SUBJECT: Wiring 4-wire 230V180 cycle power tools

DATE: 1/71

SUBJECT: Change Effective Immediately in the Field -- all
10HY35-1A and 119HY35-2 Units Equipped with or
being Converted to Automatic Idle Control

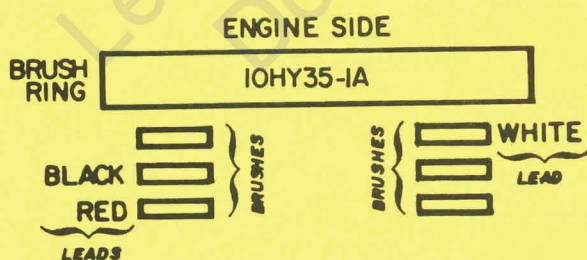
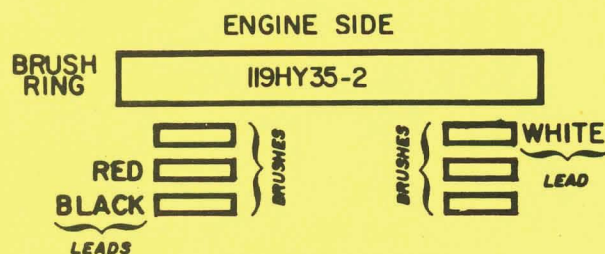
Units equipped with idle controls have a circuit that can produce a high voltage (500V) between an AC brush and DC brush. With carbon accumulation and arcing it is possible to burn a hole in the brush ring.

To correct this condition and maintain phase rotation (sequence) it is necessary to switch the three wires on the AC brushes. The procedure is as follows:

- 1) Remove the end covers.
- 2) Take a white wire from the center brush holder on the right side and connect it to the innermost brush holder.
- 3) Take the black wire from the outermost brush holder on the left side and attach it to the center brush holder.
- 4) Take the red wire from the innermost brush holder and attach it to the outermost brush holder.
- 5) Replace the end covers.

- 1) Remove the end covers.
- 2) Take the white wire from the center brush holder on the right side and connect it to the innermost brush holder.
- 3) Take the red wire from the outermost brush holder on the left side and attach it to the center brush holder.
- 4) Take the black wire from the innermost brush holder and attach it to the outermost brush holder.
- 5) Replace the end covers.

YOUR UNIT SHOULD LOOK LIKE
THIS WHEN LEAD CHANGES
HAVE BEEN COMPLETED.

YOUR UNIT SHOULD LOOK LIKE
THIS WHEN LEAD CHANGES
HAVE BEEN COMPLETED.

INSTRUCTIONS 24464 Rev.1

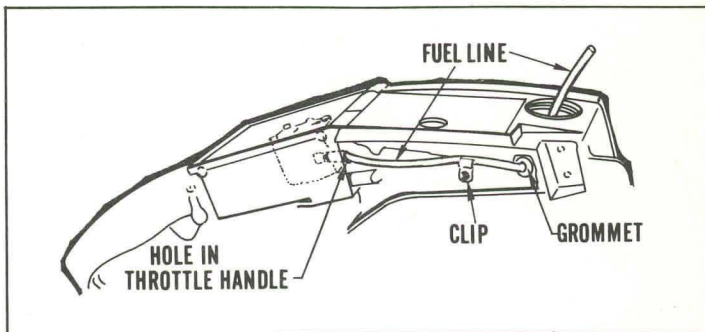
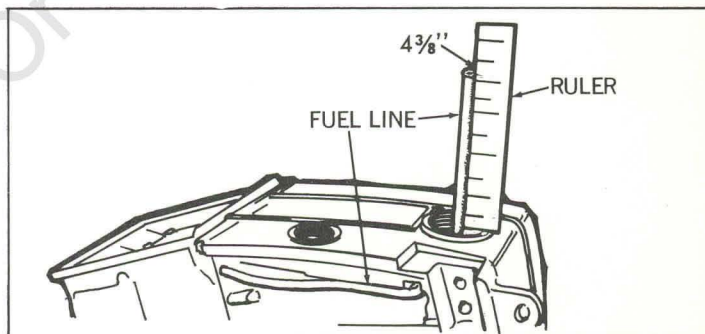
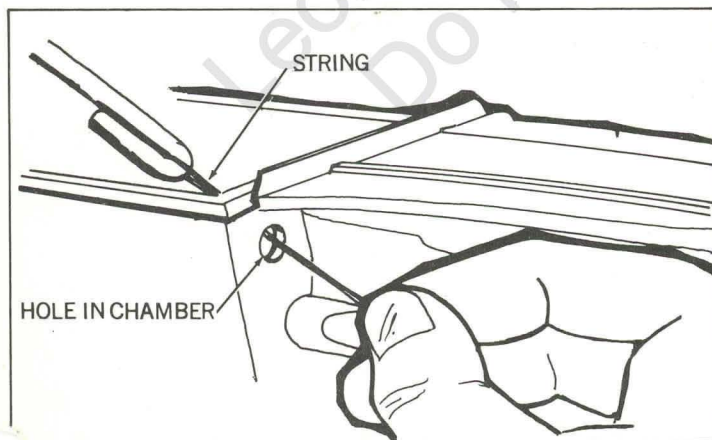
EXPLANATION OF CHANGE:

Units have been improved by substitution of a one-piece fuel line which runs from the fuel filter at its fuel tank end to the carburetor inlet fitting.

1. Remove the old fuel line and filter. Remove any burrs from the fuel outlet hole in the fuel tank.
2. Oil one end of the new fuel line and slip it onto the fuel inlet elbow of the carburetor.

- a) Units with the large diameter fuel line hole in the carburetor chamber will require Bushing 68445 to seal the hole around the fuel line.
 - b) Oil the fuel line and slide the bushing onto and up the line until it meets the elbow on the carburetor.

3. Units with the small diameter fuel line hole in the carburetor chamber should use the "String" method for feeding the new line through the hole.
 - a) Double a piece of strong, thin string and thread the loose ends through the hole from inside the carburetor chamber.

SUBJECT: 1) Magneto Air Gap
2) Crankcase to Cylinder Mating Surface Preparation

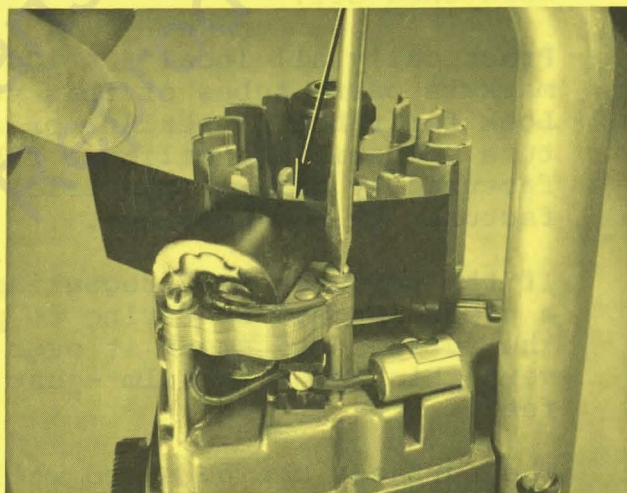
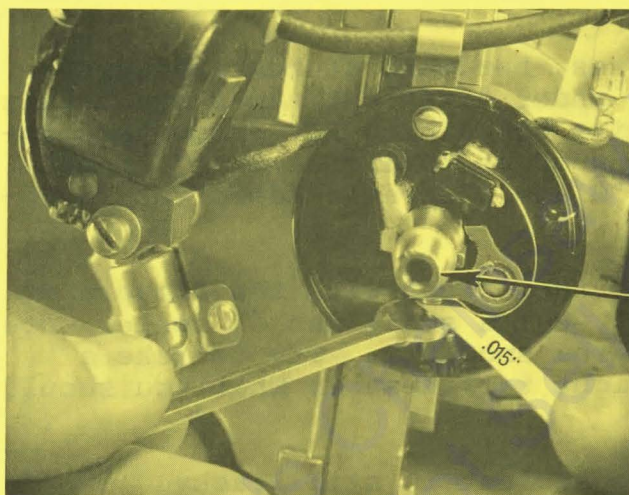
In order to set the spark timing correctly and because the Model 150 coil is mounted on the crankcase side of the shaft, it is important to take up the play in the downstroke direction while the contact point and coil core-to-rotor air gaps are being set. This is done by pushing and holding the shaft toward the bottom leg of the core during the adjustment; otherwise the gap settings will be much too narrow on the compression and power stroke.

The pictures show the gaps being set and the arrows show the direction to push. The desired air gap settings for the 150 are:

Coil core-to-rotor	---	.012" (make with #24306 shim)
Breaker gap	---	.015" (make with 7/32" wrench and #22486 feeler gauge)

SUBJECT: Oil Line Breakage XL-400

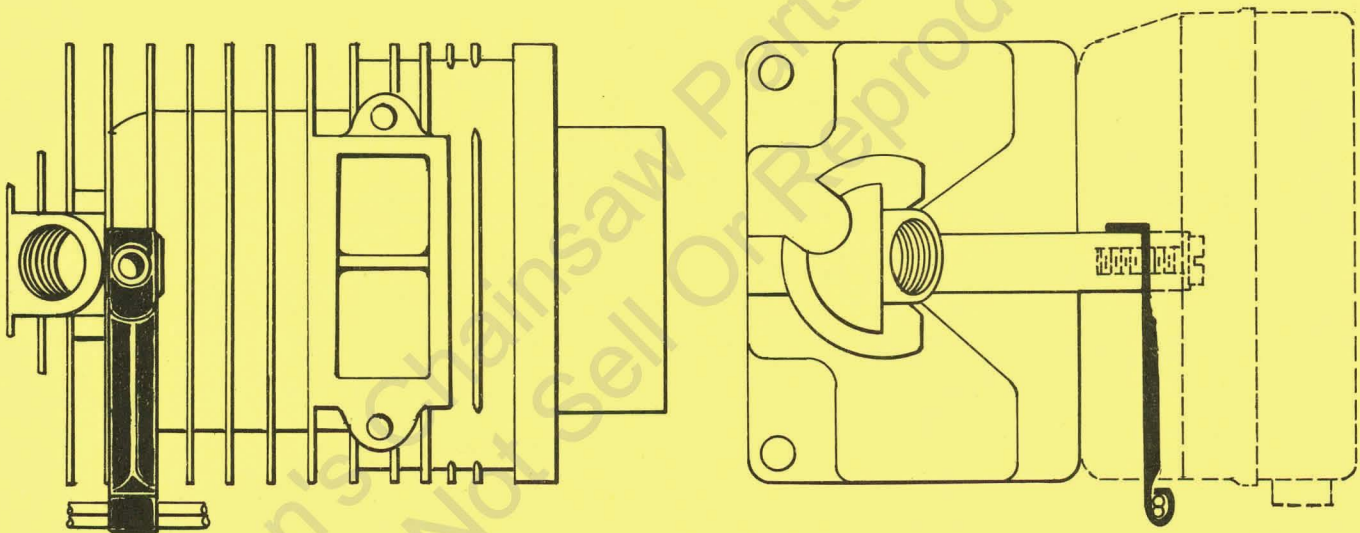
Oil housing castings are being changed to provide an area where the oil lines can be clamped to restrict movement due to vibration.

Clamp, (Part No. 68965) is available as a field fix for existing units if you encounter this problem. It is installed as shown below.

1. Remove approximately .030 (0,8 mm) from top muffler mounting boss and form clamp to fit boss.
2. Place oil lines in clamp, and squeeze clamps tight with pliers.
